PLANNING COMMISSION AGENDA

TO: Planning Commission
FROM: Eric Zuzga, Director of Community Services
DATE: June 14, 2023
SUBJECT: SLU# 23.02- 902/1102 West Hanover Street Special Land Use

TO: Planning Commission
FROM: Eric Zuzga, Director of Community Services
DATE: June 14, 2023
SUBJECT: SP# 23.04- 902/1102 West Hanover Street Site Plan

SUBJECT: 902/1102 West Hanover Site Plan

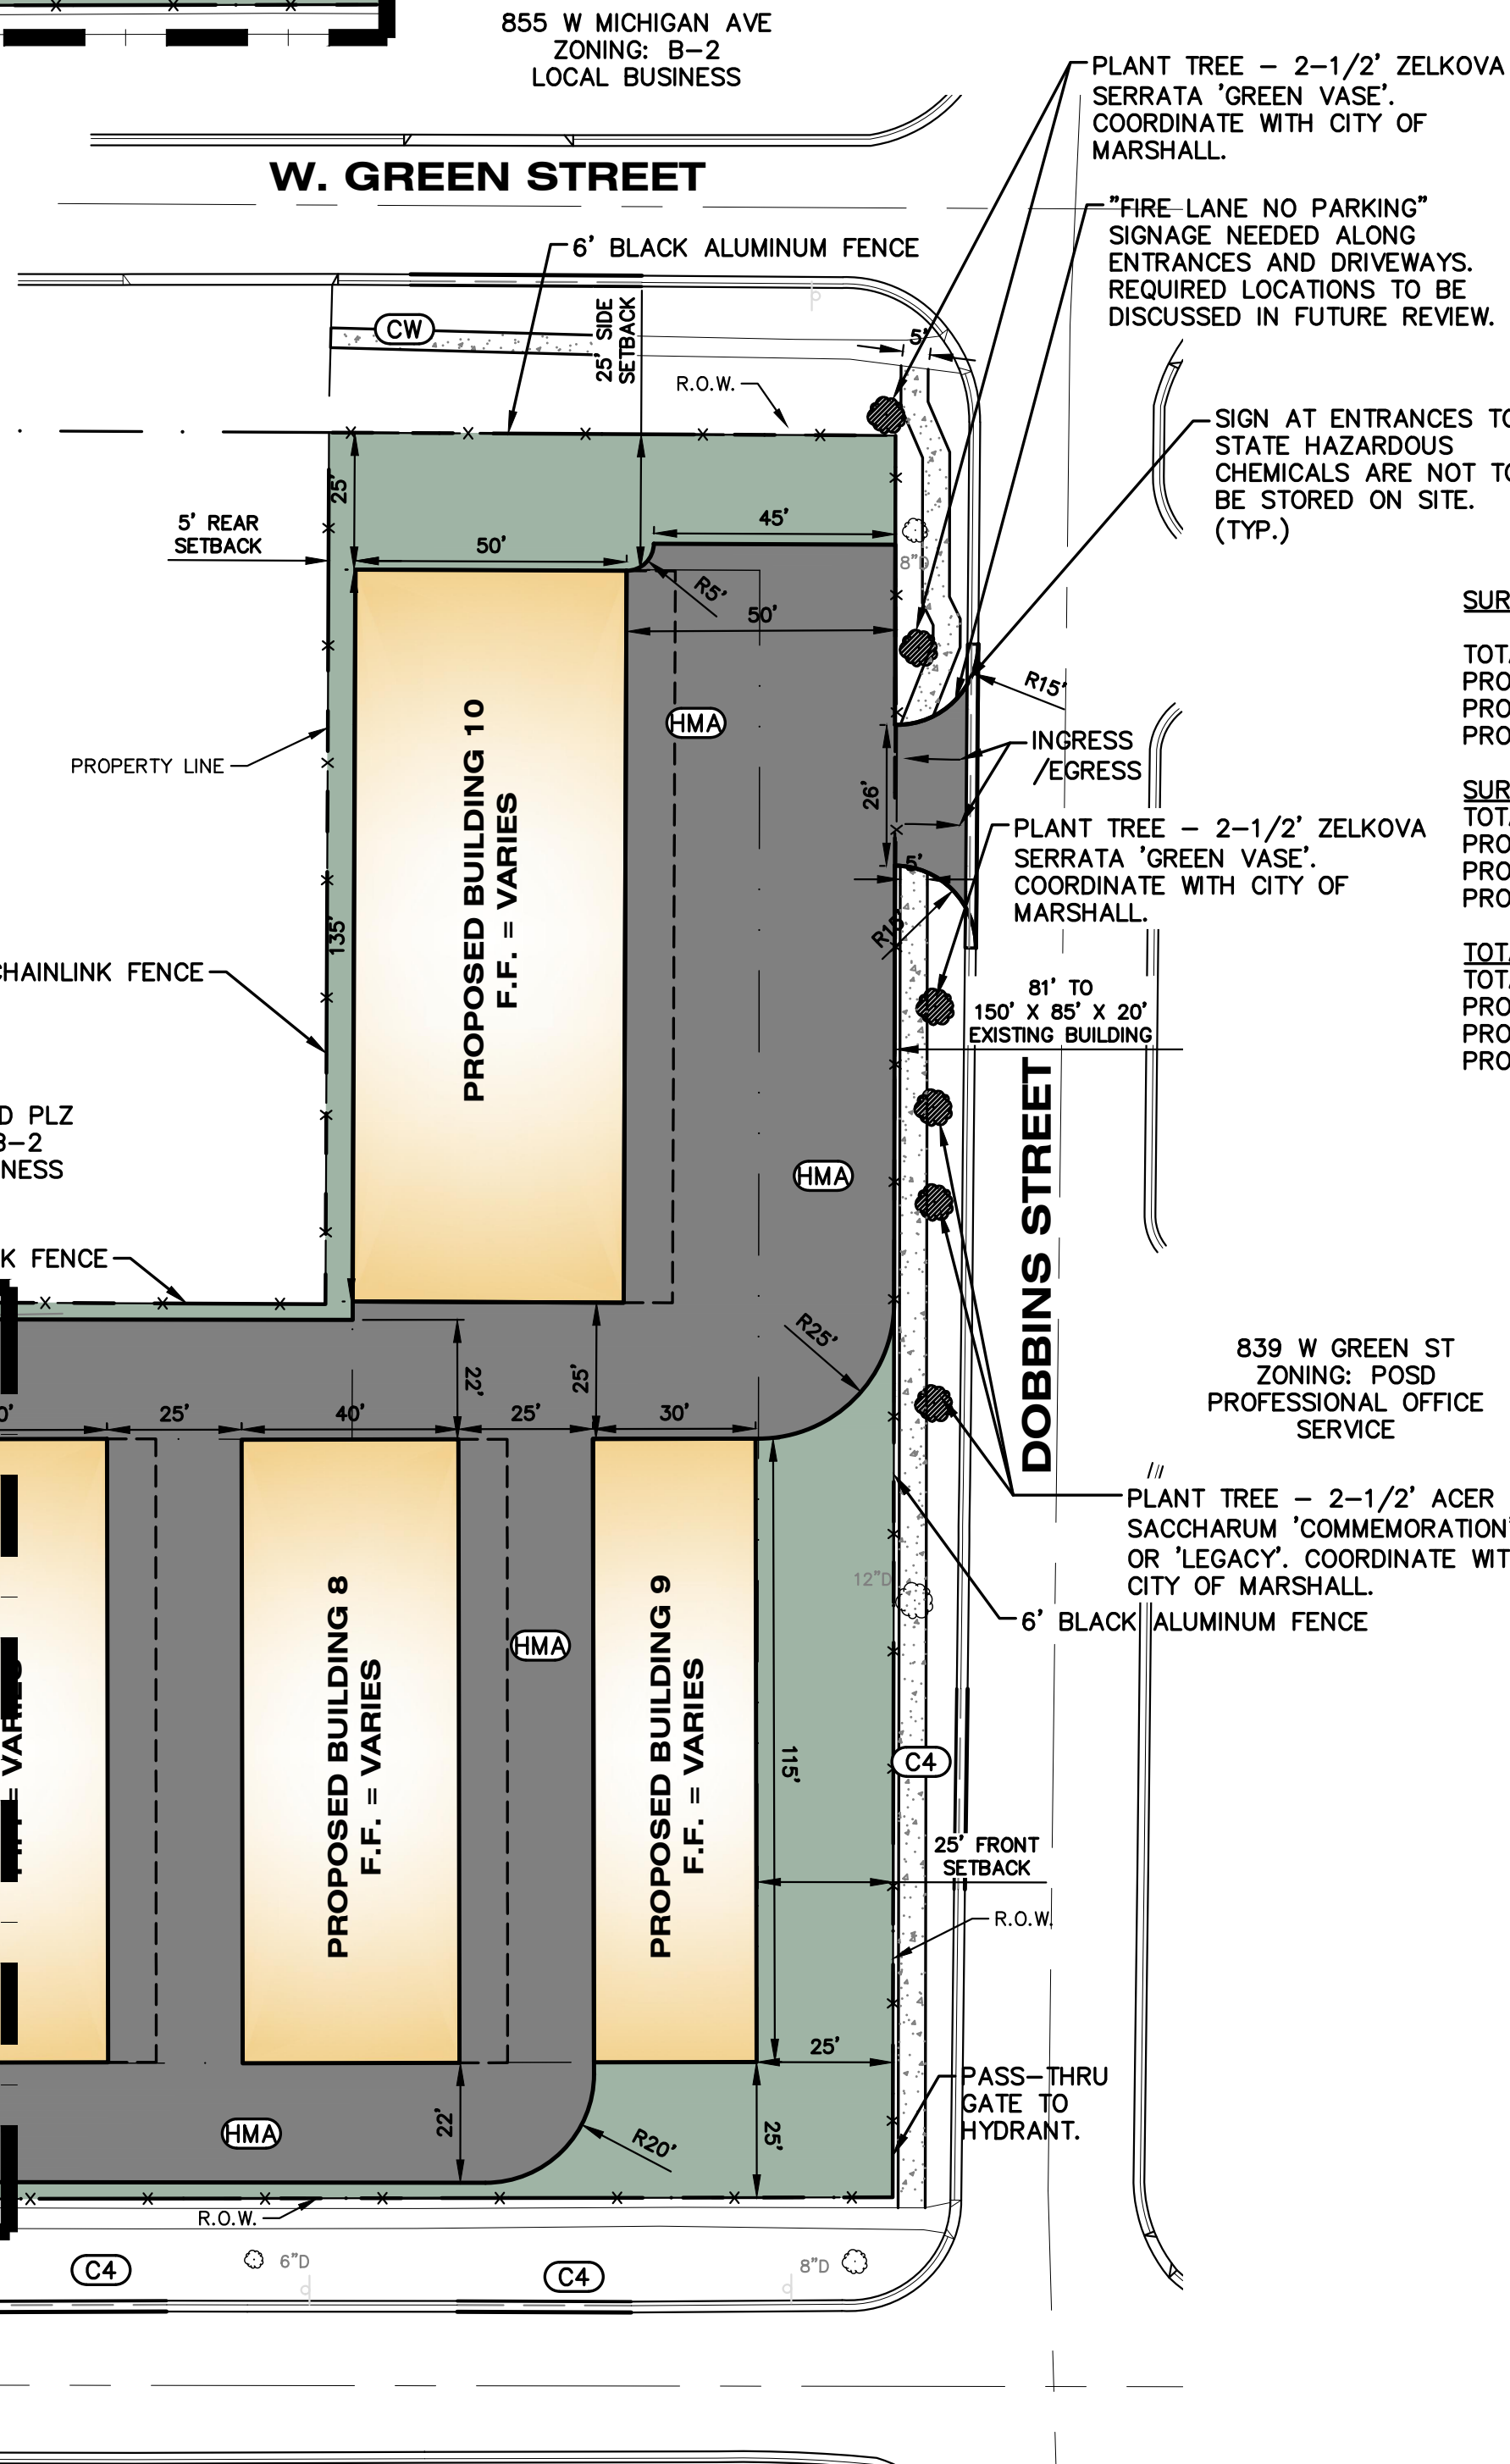
2. Please provide a chart of impervious area on C-2 by building and HMA area to tie back to impervious area in stormwater calcs. Need separated by proposed watersheds.

13. Add "FIRE LANE NO PARKING" signage will be needed along the entrances and driveways. We can discuss locations and numbers when construction drawings come in.

17. Understand your stance on parking. Provide a statement that there are X amount of spaces that exist on site for accessing of the individual units. Obviously not everyone will be there at the same time so a vehicle may take up space in front of two doors. No expectation that spaces are striped. Utilize the largest building for required spaces. I will add verbiage to my report on the ordinance standards and problems with this type of use without an office.

Response: This chart has been provided on sheet C-2.

Response: This note was added to sheet C-2.

Response: This statement has been added to sheet C-2.

Response: The pass-thru gate has been added to the southeast corner of the site, and is annotated on sheet C-2.

SITE UTILITY PLAN
HANOVER STREET STORAGE
SUNDANCER, LLC

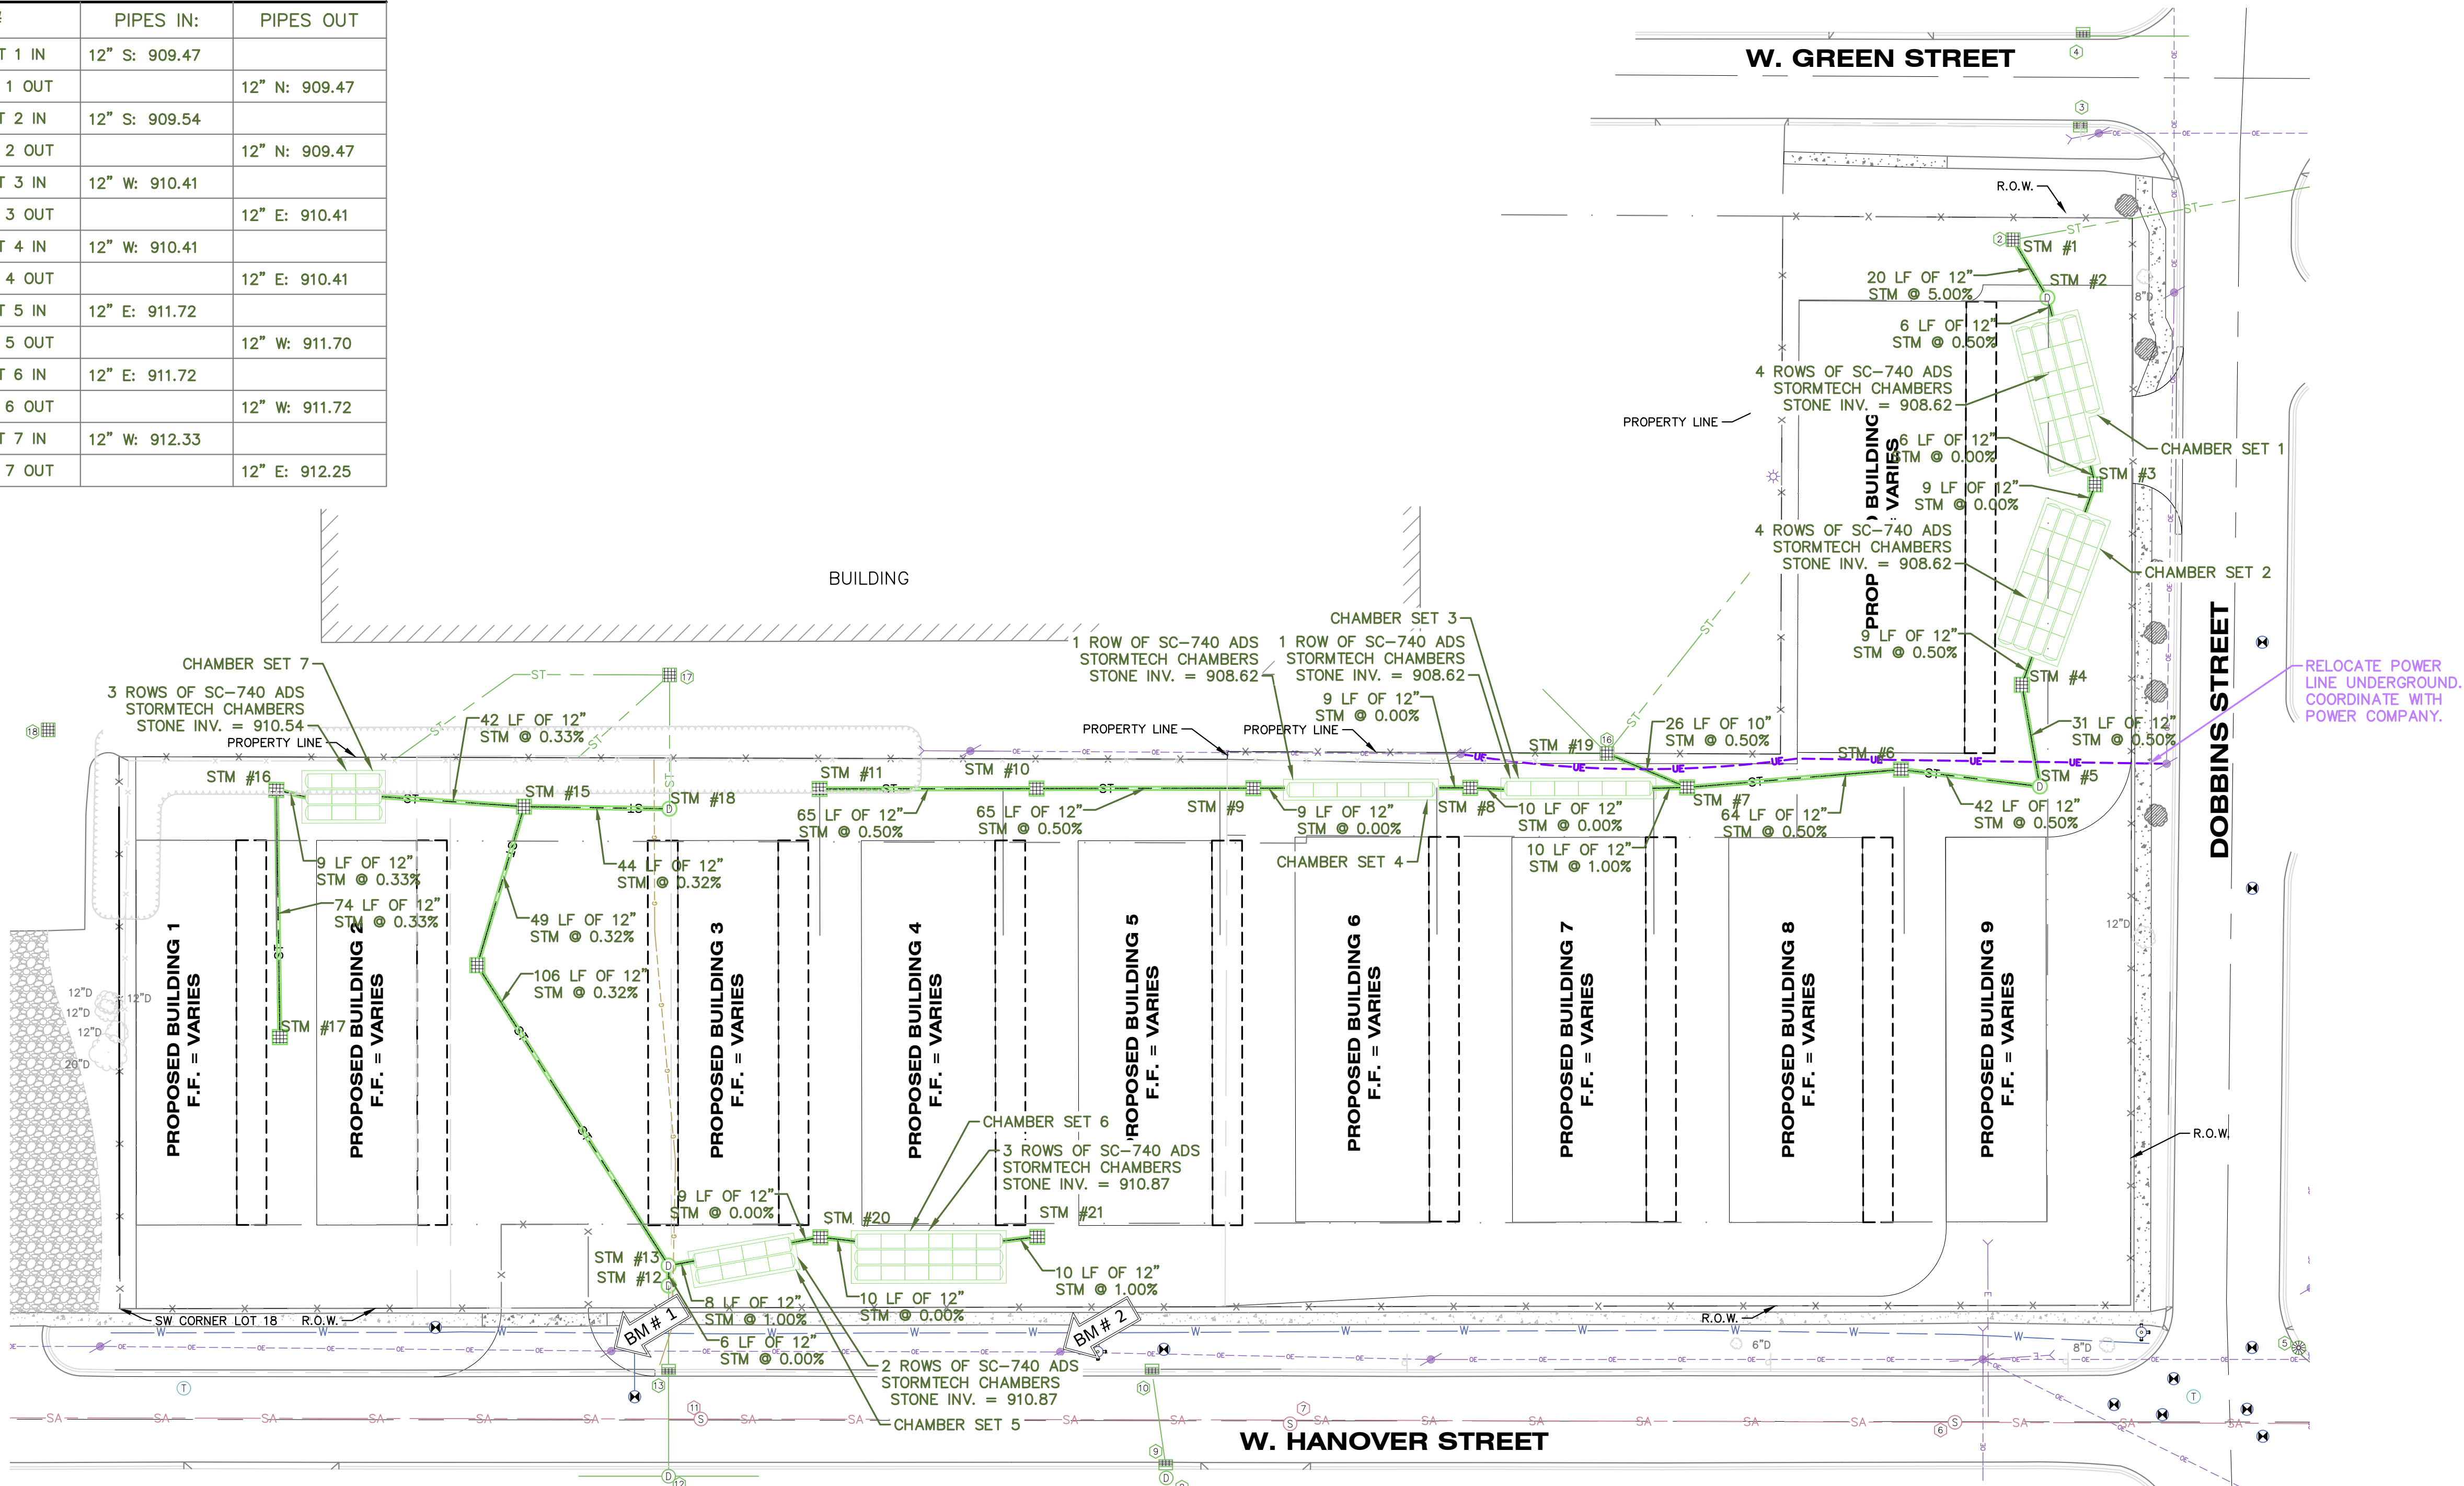
- b. The invert elevation of in and out pipes of each system is not detailed on the plans

Response: The stone invert has been shown in the detail on sheet C-6 and refers to the utility plan, sheet C-4 for specific elevation of the bottom of stone.

Response: The invert elevation for the inlet and outlet have been added to the storm structure table.

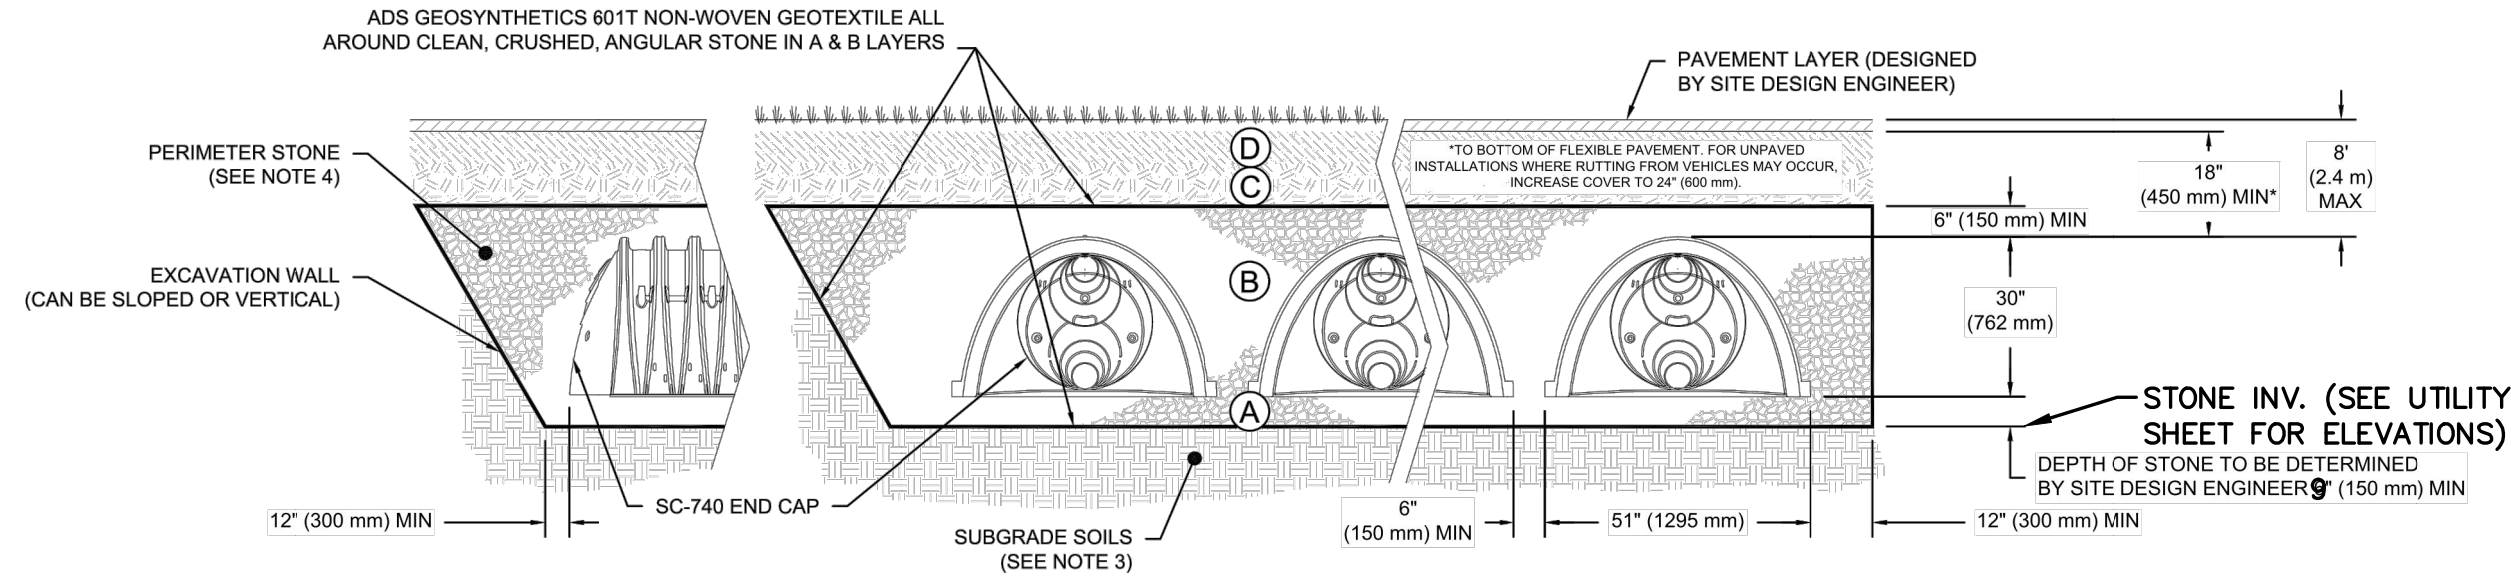
- c. Show elevation of ‘storage volume’ as outlined in the stormwater calcs. Need justification on specified stone material and calculated storage. – justify 40% voids used in stormwater chamber calcs.

Response: Stormtech’s standard detail sheet calls for AASHTO M43 stone to be used. According to AASHTO, M43 has a 40% void ratio.

Response: Please refer to the 45-inch height of system volume as there is 9 inches of stone followed by the 30-inch tall chamber, followed by an additional 6 inches of stone, resulting in a total system height of 45 inches. These volumes correspond to the required volumes in Hurley & Stewart’s calculation sheets.
